BCA ASSESSMENT MEMO REPORT

TO:	Genton	PROJECT #	210450
ATTENTION:	Steven Toia	DATE:	28 February 2022 (Rev.1)
EMAIL:	Steve.Toia@genton.com.au	PAGES:	8
FROM:	Dean Goldsmith		
SUBJECT:	WS2, Fujitsu Greystanes Data Centre Project, 4 Bellevue Circuit Greystanes – MEP Plant Structure

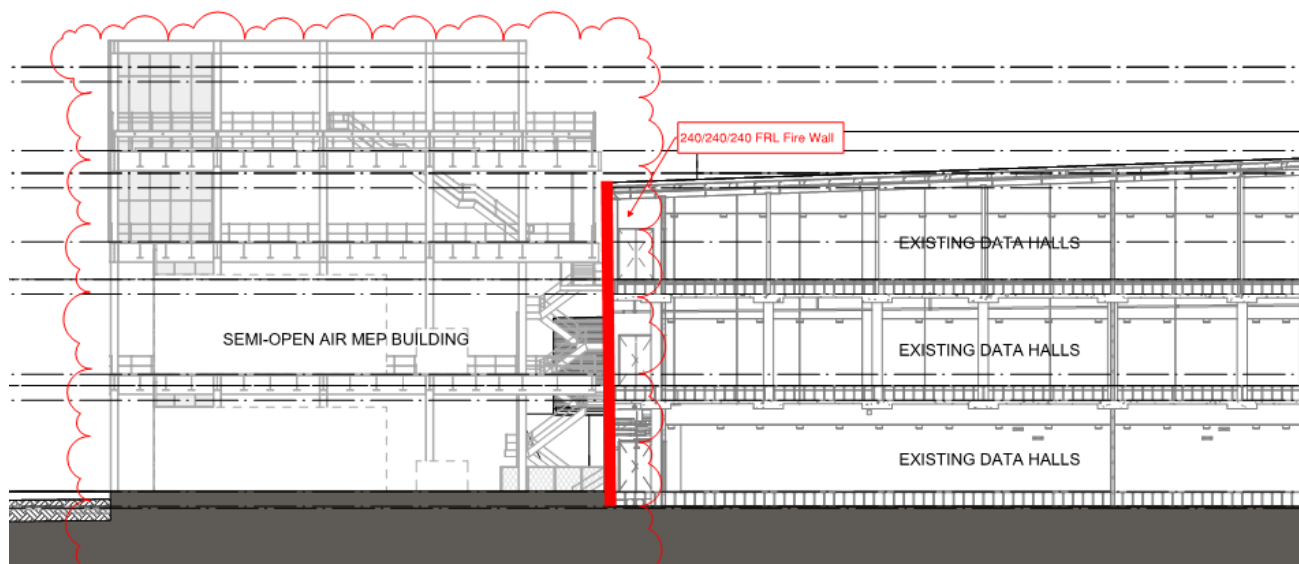
A wall and ceiling lining system must comply with the group number specified below and must have:

- A smoke growth rate index not more than 100; or
- An average specific extinction area less than 250 m²/kg

Class of Building	Public corridors	Other Areas
Class 5 (Sprinkler Protected)	Walls: 1, 2, 3 Ceiling: 1, 2, 3	Walls: 1, 2, 3 Ceilings: 1, 2, 3

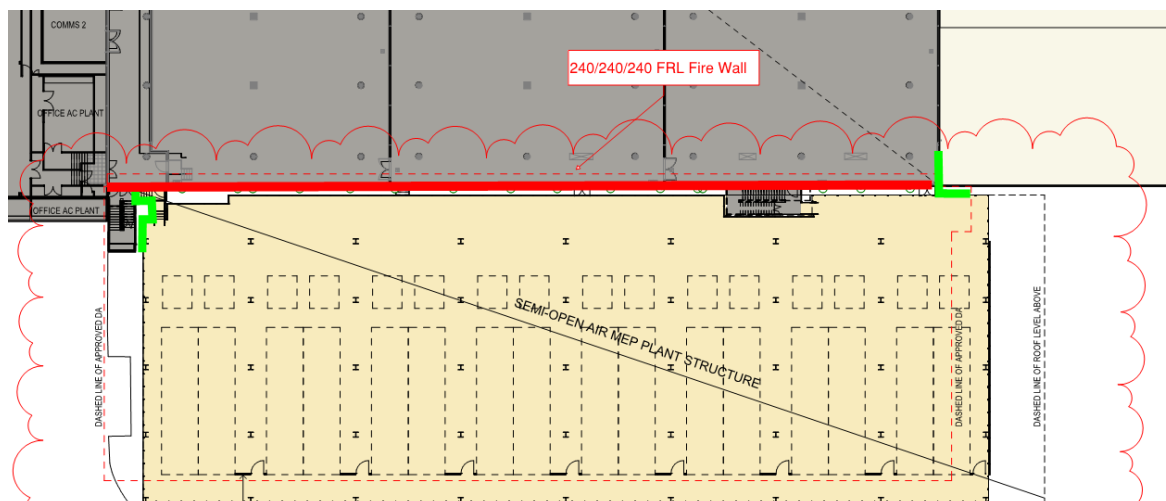
- + **Clause C3.3 – Separation of External Walls and Associated Openings in Different Fire Compartments:** Further to the comments in C2.2/C2.7 above, compartmentation plans are to be provided by Genton to determine where additional protection is required to the external walls in the adjoining fire compartments on each level (see indicative zone marked in green below) – similar to the above compartmentation and fire rating issues, a Performance Solution from the Fire Engineer may be considered to address this requirement.
